TO: Francie Barker
FROM: Steve Hambos
RE: Changes in Monitoring Well Placement at the Asbestos Disposal Sites.
DATE: December 12, 1986

This memorandum is submitted to address field changes that were incorporated into the National Gypsum Remedial Investigation at the Millington and "satellite sites". These changes deal with alternate placement of monitoring wells at the satellite sites and are summarized below.

FIGURE 1

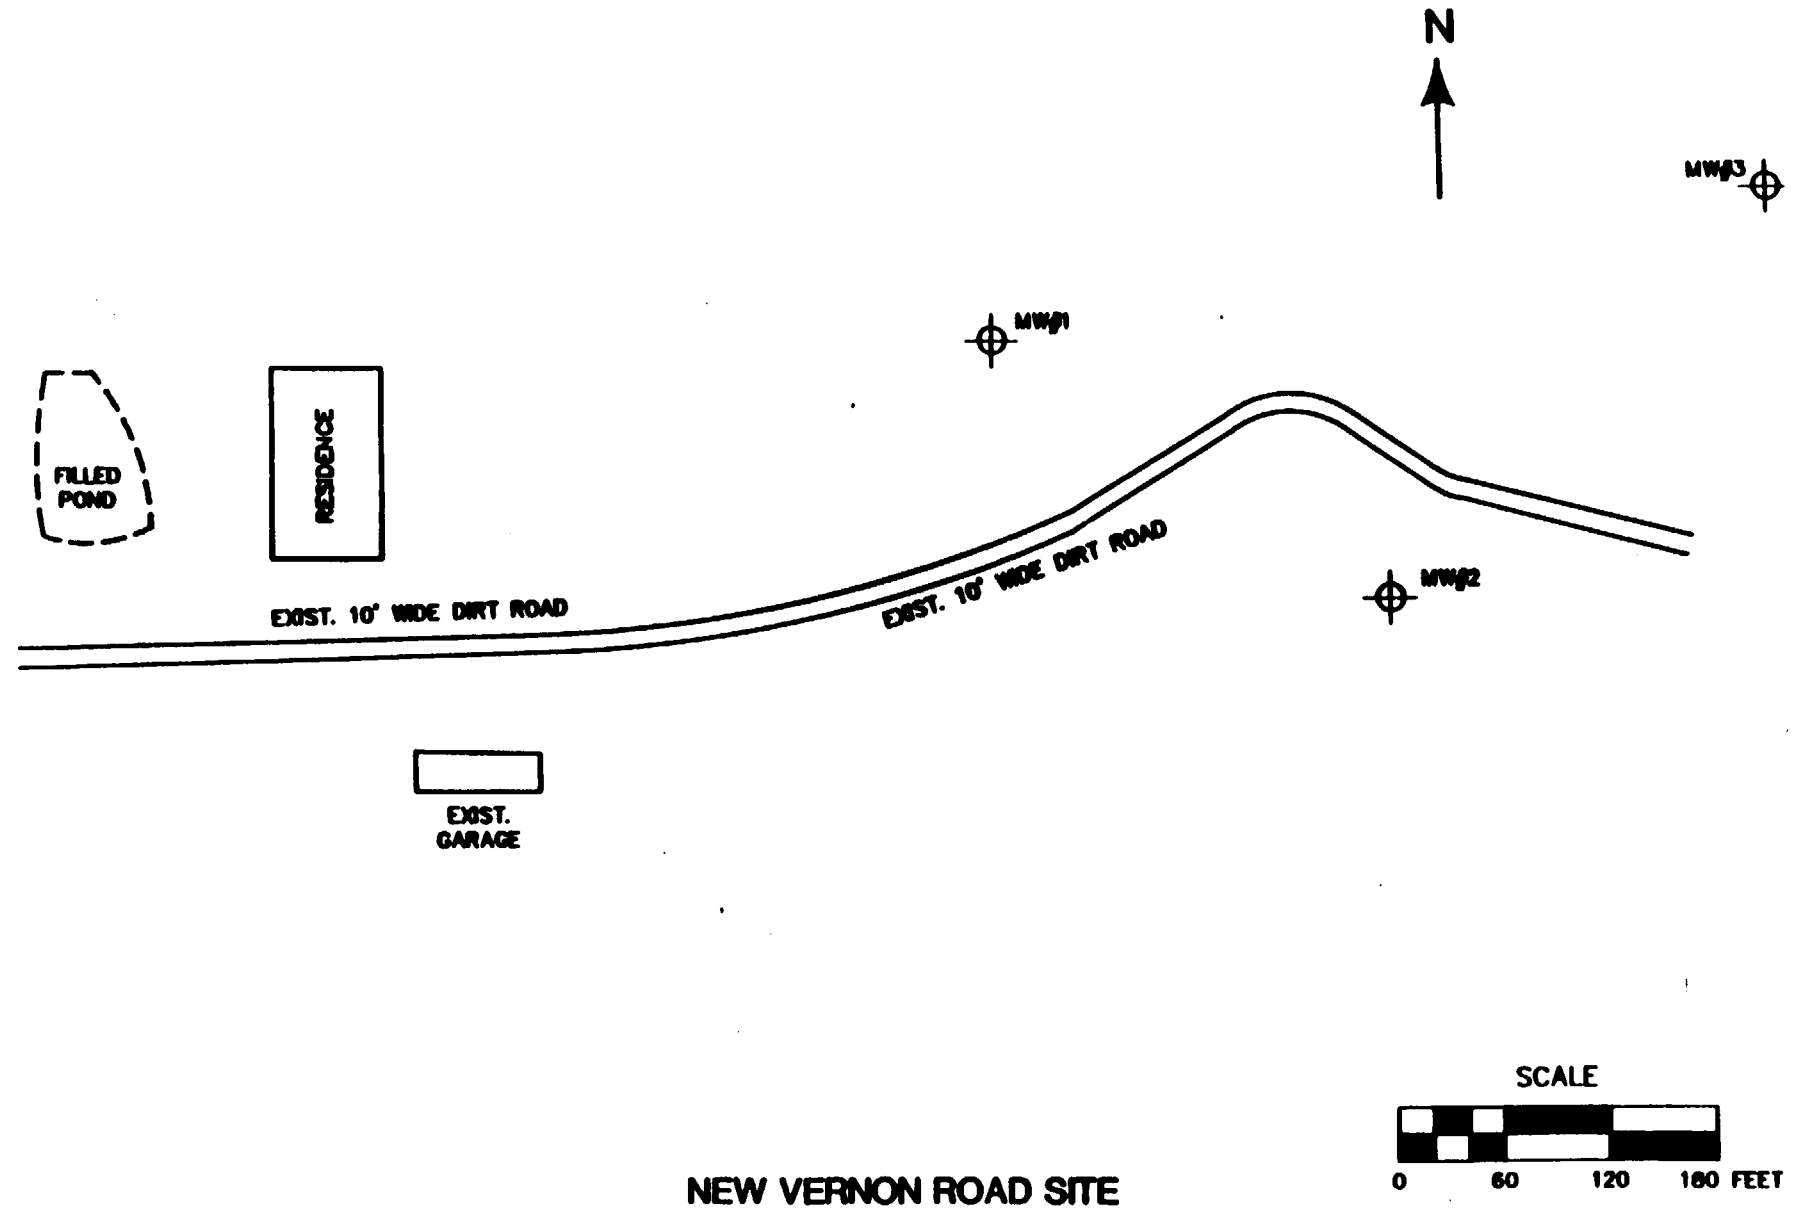
1. New Vernon Road Site. The Site Operations Plan (SOP) for this site (pg. 2-13) specified that three groundwater monitoring wells would be placed around the garage located just south of the Tiemann residence. Instead, all three monitoring wells were moved to surround the former disposal site located approximately 700 feet east of the residence (Figure 1). This dump site represents an area of intensive landfilling that took place over the course of many years, whereas, the garage is situated over an area that was surficially covered with asbestos products. Aerial photographs supplied by USEPA and information from Mr. Tiemann, the property owner, assisted in the identification of the former landfill site and placement of the monitoring wells.

FIGURE 2

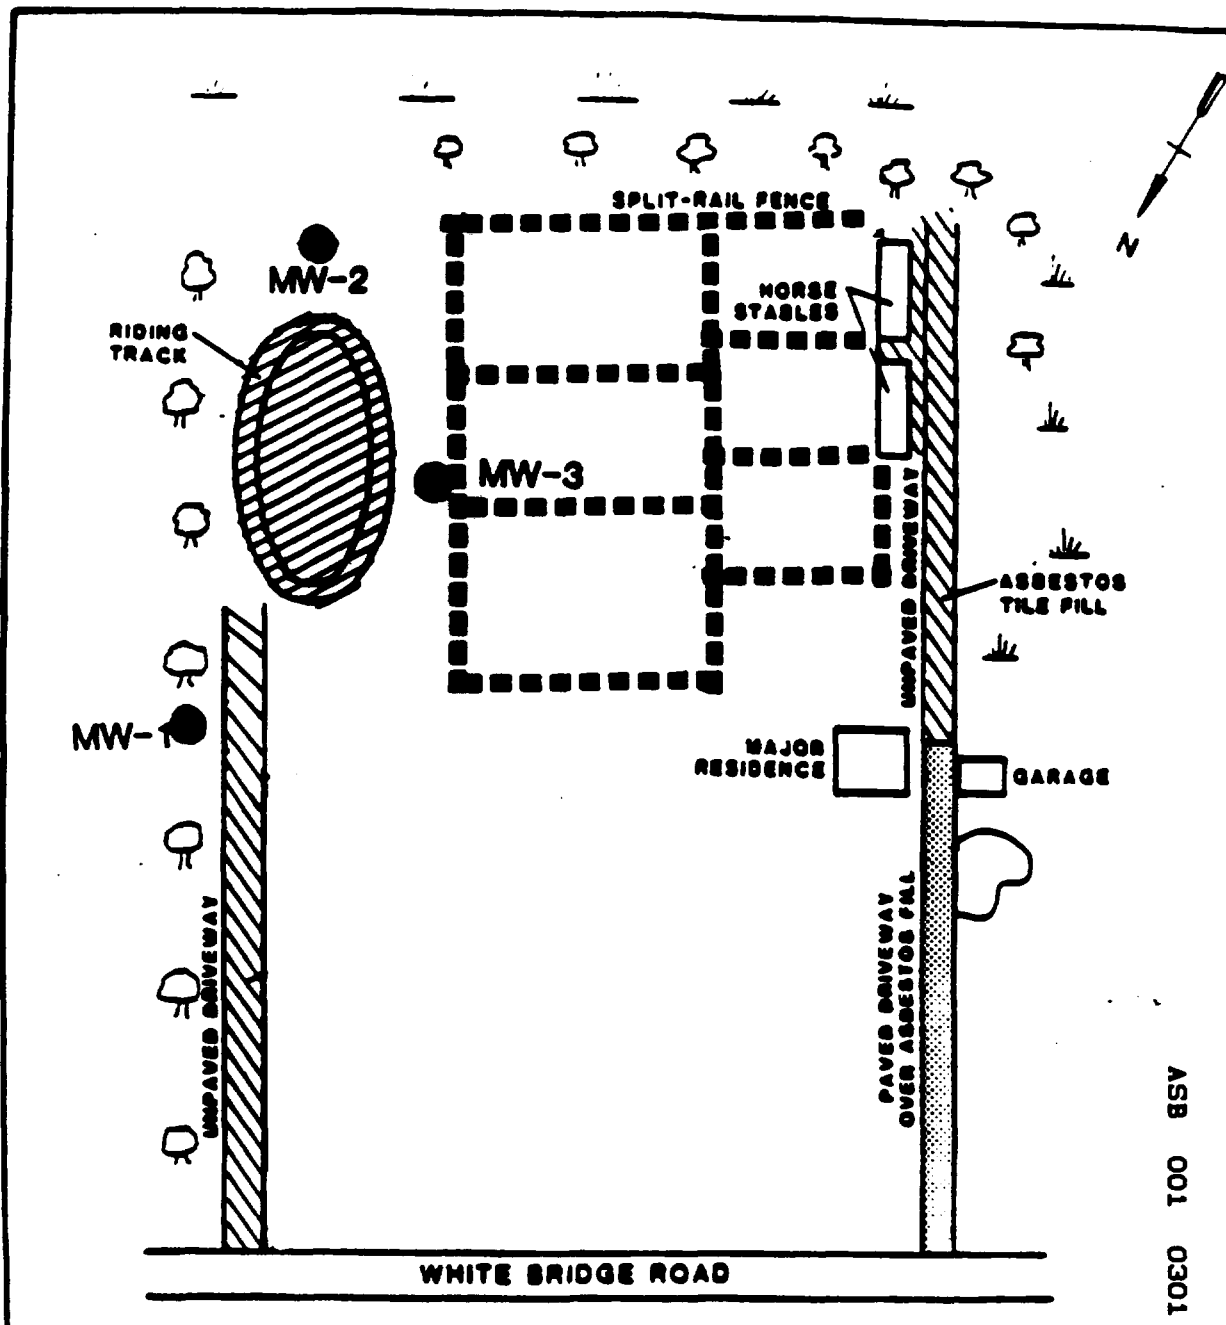
2. White Bridge Road Site. The only change incorporated at this site concerned the placement of the northern monitoring well. This well was designated as #3 in the SOP (pg. 2-12) and #1 in our field effort, as

shown in Figure 2. This well was placed 50 feet east of the original designation in an area better suited to boring activities.

FIGURE 3

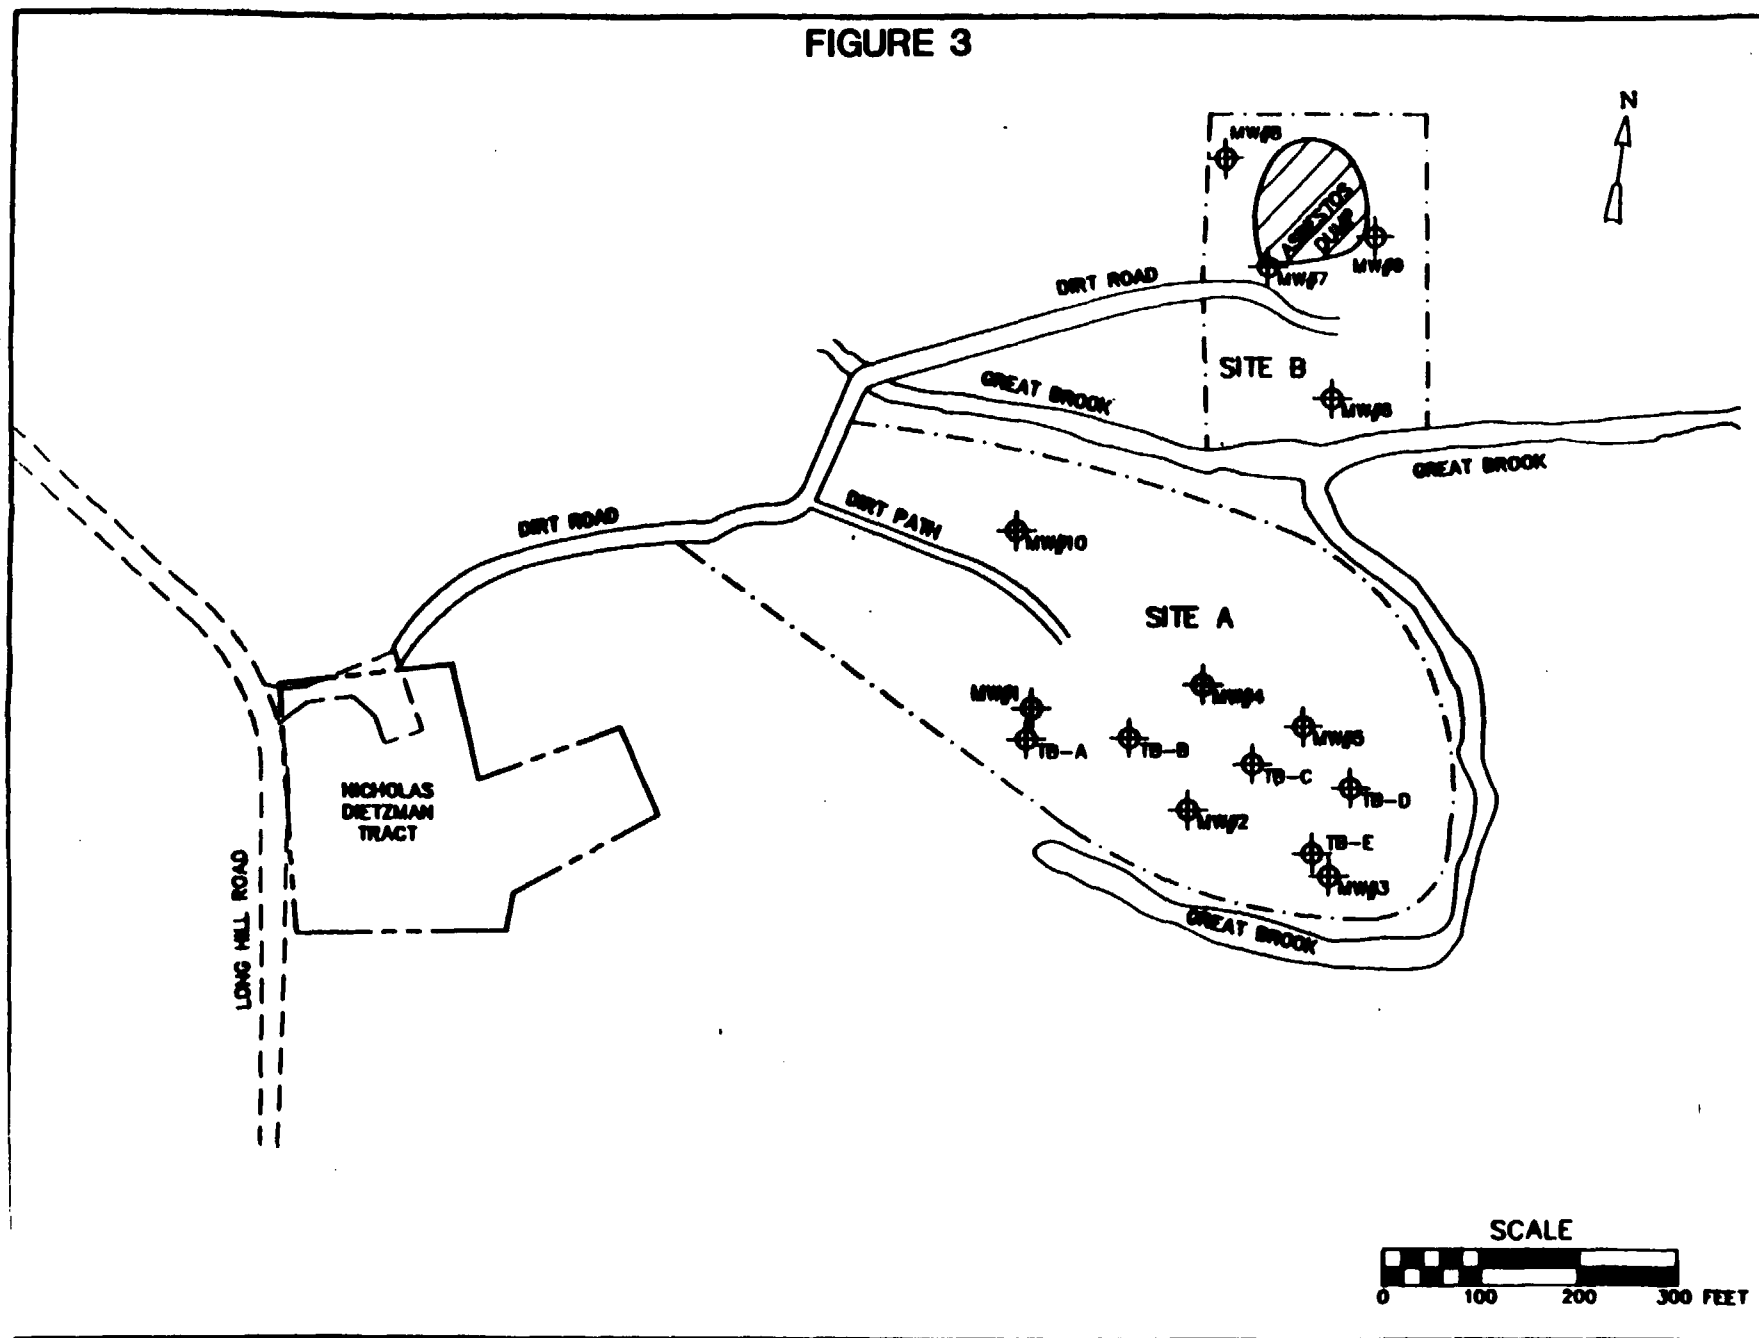
3. Great Swamp Site. During the preparation of the SOP, Fred C. Hart Associates (HART) was only aware of one disposal site within the refuge. As a result, placement of ten monitoring wells was designated around this site (SOP, pg. 2-11). Following a site visit and discussion with refuge personnel, a second considerably more extensive landfill site was brought to the attention of HART personnel. As a result, six of the original ten monitoring wells were placed at this new site (designated Site A in Figure 3), while four of the remaining ten monitoring wells were situated around the original disposal area (designated Site B in Figure 3).
